21154 PCI-to-PCI Bridge

Specification Update

July 2004

Figure 1. S_Clock Multiplexer Workaround Circuit for Errata 6.

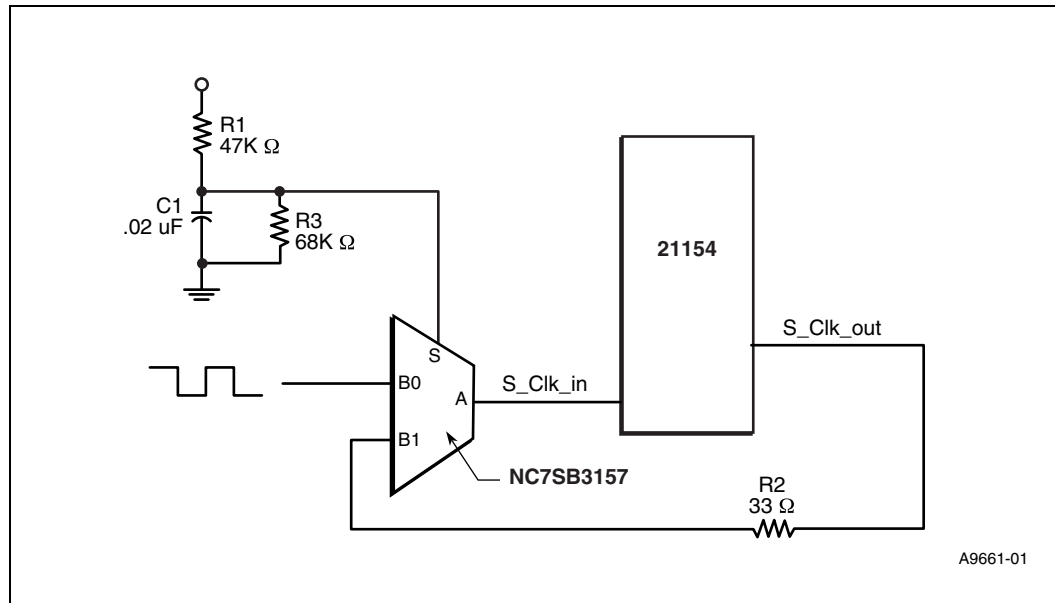
6. Secondary Clocks Outputs s_clk_o<9:0> May Not Start-up Properly Under Some Conditions

Problem: This problem has been found on the 21154AC and 21154BC. Under repeated and frequent power cycling, the secondary clock circuits may not power up in the proper state, resulting in the device not coming out of reset after power up.

Implication: In a system with a 21154AC or 21154BC that has one of its s_clk_o<9:0> outputs fed back to provide the s_clk, it is possible that the s_clk_o<9:0> output clocks will be driven and remain low, keeping s_rst_l asserted, during system power up.

1. [Figure 1](#) illustrates the first recommendation - a circuit where an on-board pulse source is gated via the B0 input of the multiplexer to the S_Clock_in pin of the 21150.

At time 0, the S input of the multiplexer is low, allowing pulses from the on-board pulse source, connected to the B0 input, to be provided to the 21150 S_Clk input pin. When the time determined by the R/C network is satisfied, the S input pin will be in a logic High state. The multiplexer will then shut off the input pulse from S0 and will direct the S_Clock_out pulses via the B1 multiplexer input, into S_Clock_in

The values used for the R/C network should be selected to allow a minimum of 2 pulses to be delivered to the 21150 after Vdd has reached 3.0V at a frequency not to exceed the appropriate PCI component. i.e. 30 ns for a 33Mhz bridge. These values should be chosen based on the rise time of the power supply and the frequency of the on board pulse source. The values given for R1, R3, and C1 are for example purposes only.

Note: The NC7SB3157 2:1 Multiplexer / Demultiplexer Bus Switch used in this example has a maximum propagation delay of 800ps that should be taken into consideration when matching trace lengths of the clock lines to avoid introducing excessive skew in the clocks. All S_Clock etch lengths must be matched to within 2ns @ 33Mhz or 1ns @ 66Mhz. The addition of this circuit requires that the etch length for the S_clock_in signal be reduced to compensate for the 800ps delay.

Figure 2. Recommended Circuit for a Tristable Buffer

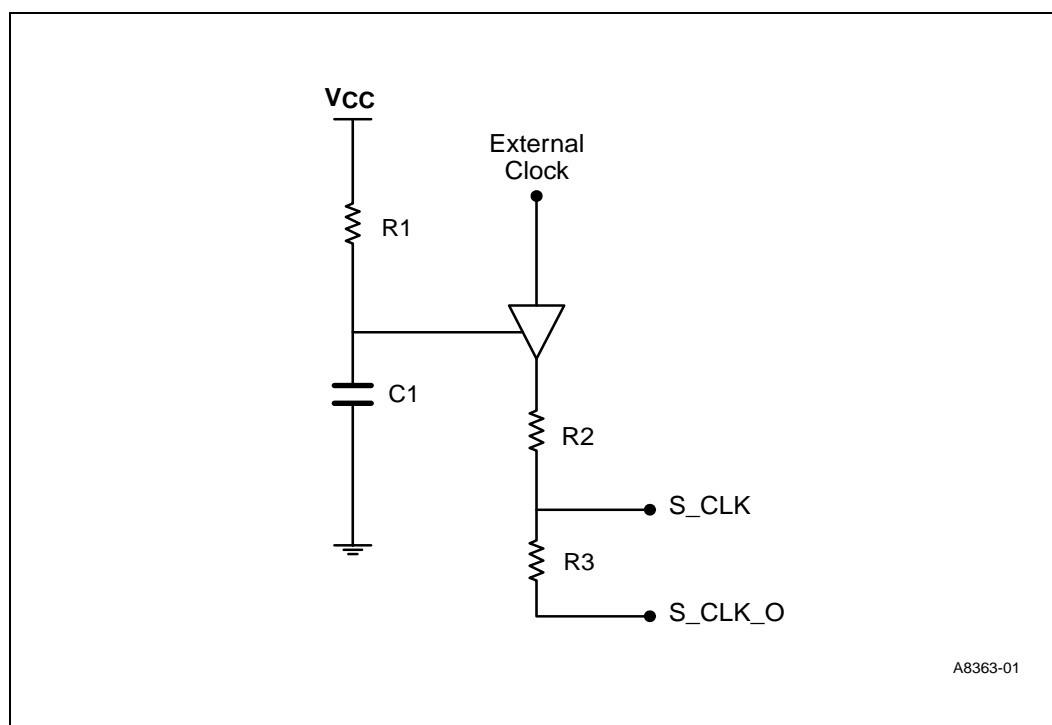
2. In the second recommendation, to guarantee the proper initialization of the **s_clk** circuits, the addition of an external circuit that provides a minimum of two transitions on the **s_clk** input during the power-up ramp is necessary. This can be done using a solution that drives an external clock onto the **s_clk** input while 3.3V Vcc is ramping during power up.

Figure 2 illustrates the use of a tristable buffer to provide multiple pulses to the **s_clk** input. The Vcc ramp rate and R1,C1 time constant determine the duration and amplitude of the pulses generated during power up. The R2-R3 values are chosen based on applicable board etch impedance-matching requirements.

The following should be considered in calculating the R1,C1 time constant:

- Make the time constant of the circuit as short as possible, while still ensuring that a minimum of two pulses are generated during the Vcc ramp.
- Phase delay between **s_clk_o** and the external clock should be minimized.
- Matching the external clock and **s_clk_o** frequencies to reduce contention.
- Laboratory experiments using **p_clk** as the external clock and a R1C1 time constant between 40 and 60 percent of the Vcc ramp have been successful using this configuration. However the use of **p_clk** as the external clock violates the PCI bus specification for loading of the primary clock.

Figure 6. Removal of Pull-Down Resistor for JTAG Testing

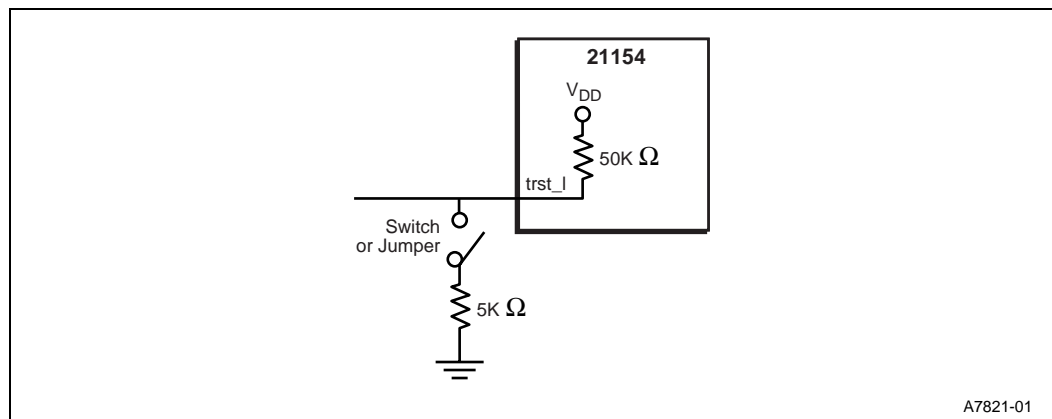
9. Section 6.3.1, Signal trst_l Pull-Down Resistor, New Section

A 5 K Ω pull-down resistor is required on trst_l for normal PCI-to-PCI bridge operation. However, some JTAG test results may be inconclusive if the 5 K Ω resistor remains in the circuit. To obtain accurate JTAG results, Intel recommends one of the following solutions:

- Verify that the JTAG test equipment, after driving trst_l low to reset the TAP controller, constantly drives trst_l high during JTAG tests. If this signal is not constantly driven high, the 5 K Ω resistor will pull the signal to a low state.
- Remove the 5 K Ω resistor during JTAG tests. This resistor must be installed during normal PCI-to-PCI bridge operation.
- Design external circuits with a switch or jumper to isolate the 5 K Ω resistor during JTAG tests (see Figure 6). This switch must enable the resistor during normal PCI-to-PCI bridge operation.

Figure 19 Example of GPIO Clock Mask Implementation on the System Board

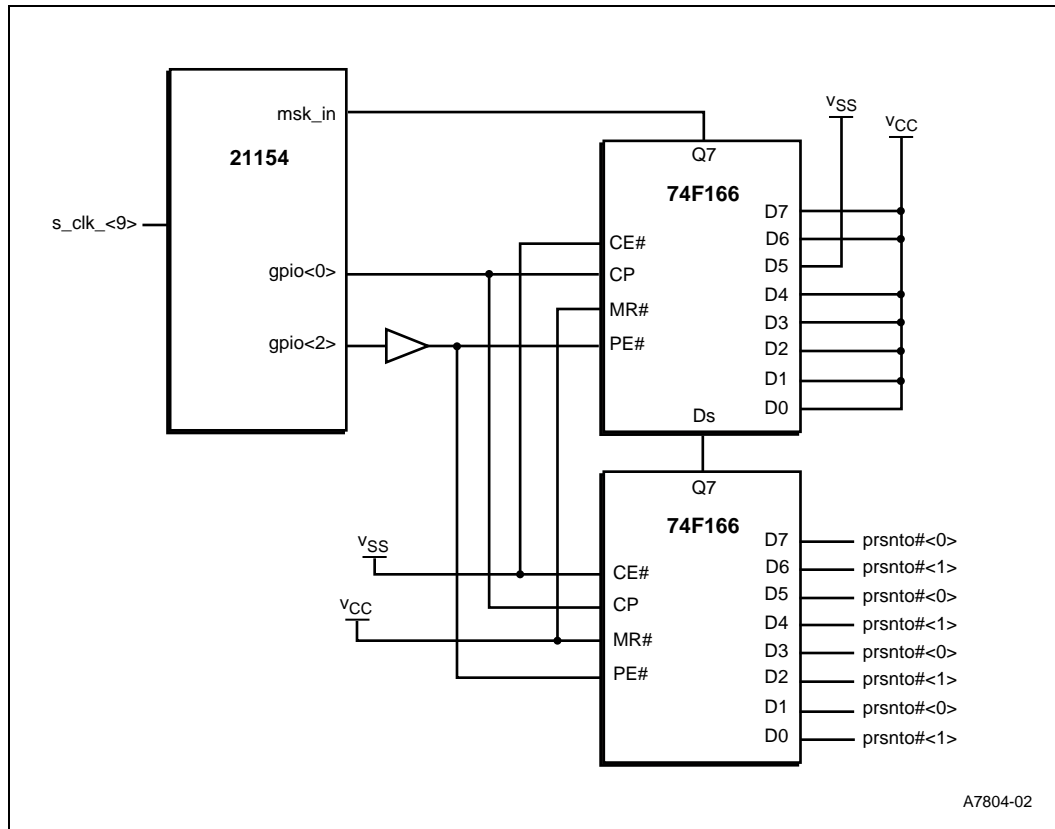
12. Section 10.2, Secondary Clock Control, Figure 19

This figure now appears as follows:

Figure 20. Clock Mask and Load Shift Timing

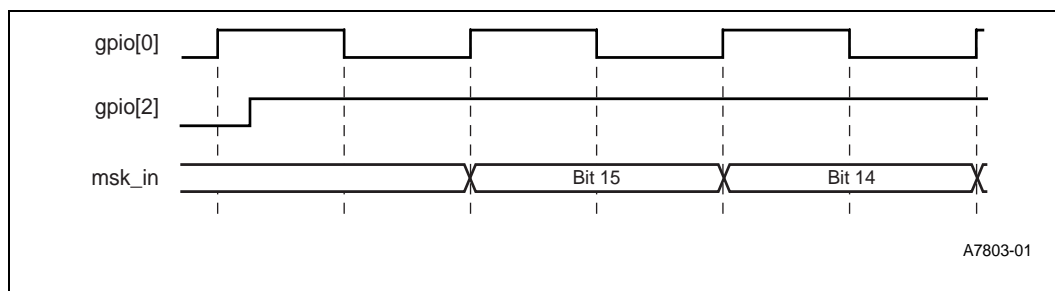
13. Section 10.2, Secondary Clock Control, Figure 20

This figure now appears as follows:

Figure 21. Clock Mask and Load Shift Timing

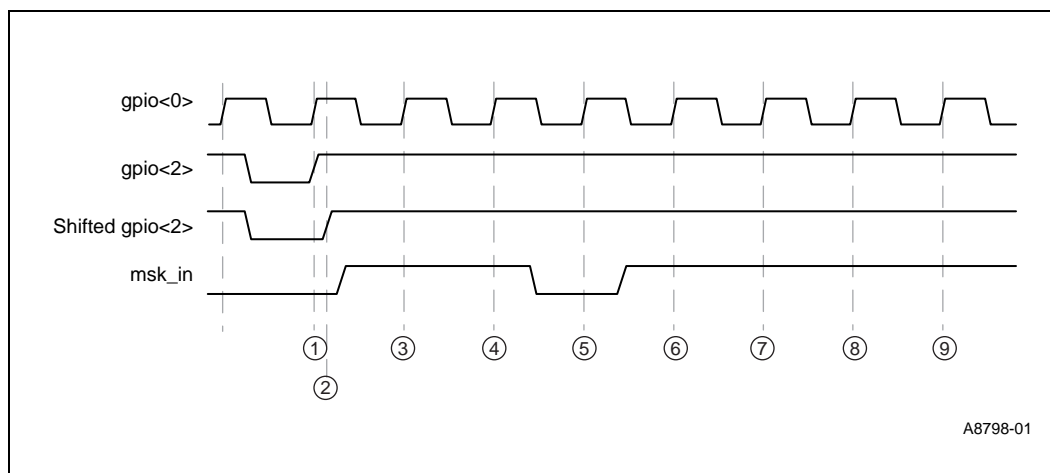
15. Section 10.2.1, Mask and Load Shift Timing Events for 66 MHz Operation

The following list provides the timing sequence for 66 MHz operation for an example circuit as shown in [Figure 19](#) and the timing diagram in [Figure 21](#).

1. The **gpio<2>** original coming from the 21154 does not provide 3ns setup time needed to provide the parallel load enable **PE#** of the 74F166.
2. The shifted **gpio<2>** is delayed by ~9ns to provide ample setup time to enable the parallel of the shift register connected to pin 15 of the 74F166.
3. Bit 15 input **D6** of the shift register is pulled high, to Vcc.
4. Bit 14 input **D7** is pulled high, to Vcc. These signals are not used internally in the 21154.
5. Bit **13 s_clk_o<9>** is a feedback to the 21154 **s_clk_o** input. To enable **s_clk_o<9>** in all cases the **D5** input of the shift register is grounded, to Vss.
6. Bit 12 **s_clk_o<8>** is disabled.
7. Bit 11 **s_clk_o<7>** is disabled.
8. Bit 10 **s_clk_o<6>** is disabled.
9. Bit 9 **s_clk_o<5>** is disabled.

Figure 3 Example of GPIO Clock Mask Implementation on the System Board

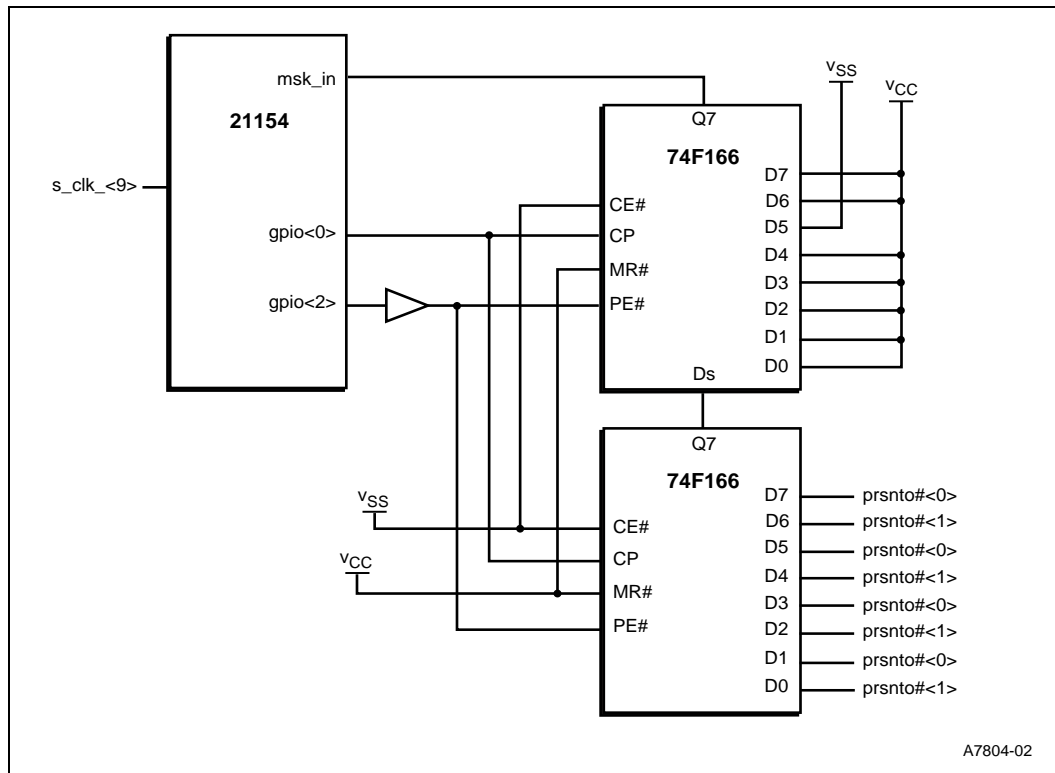
18. Section 4.4.1, Serial Clock Mask Shift, Figure 3

Figure 3 has been updated as follows:

Figure 4. Clock Mask Load and Shift Timing

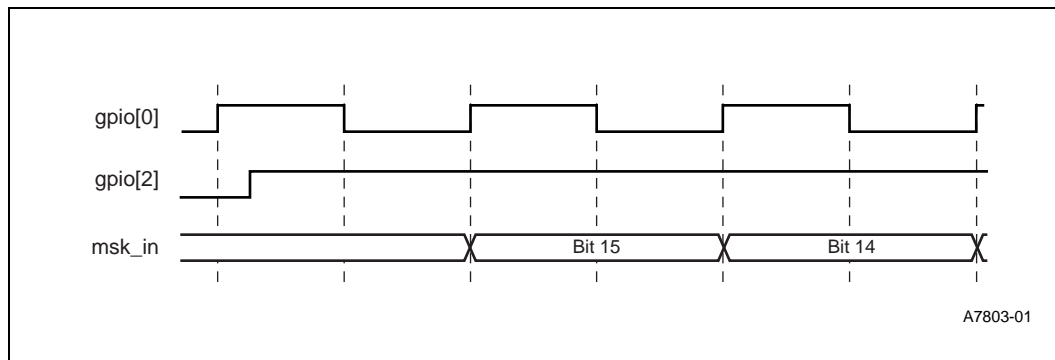
19. Section 4.4.1, Serial Clock Mask Shift, Figure 4

Figure 4 now appears as follows:
